GXV3480/3470/3450 Firmware Release Notes

FIRMWARE VERSION 1.0.1.21

GXV3480, GXV3450, GXV3470

ZOOM MODE

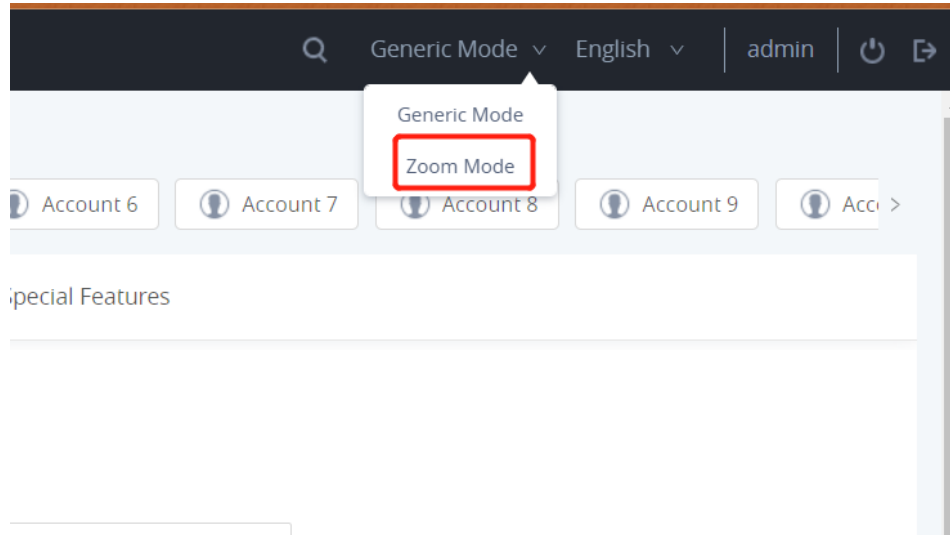
- Supported Zoom Mode. [ZOOM MODE]

The Zoom Mode is added to the web UI to integrate the device to Zoom app to the fullest. Switch to Zoom Mode from top right of web UI like below. The device will automatically start Zoom app. When enabled, only Zoom app runs on the phone.
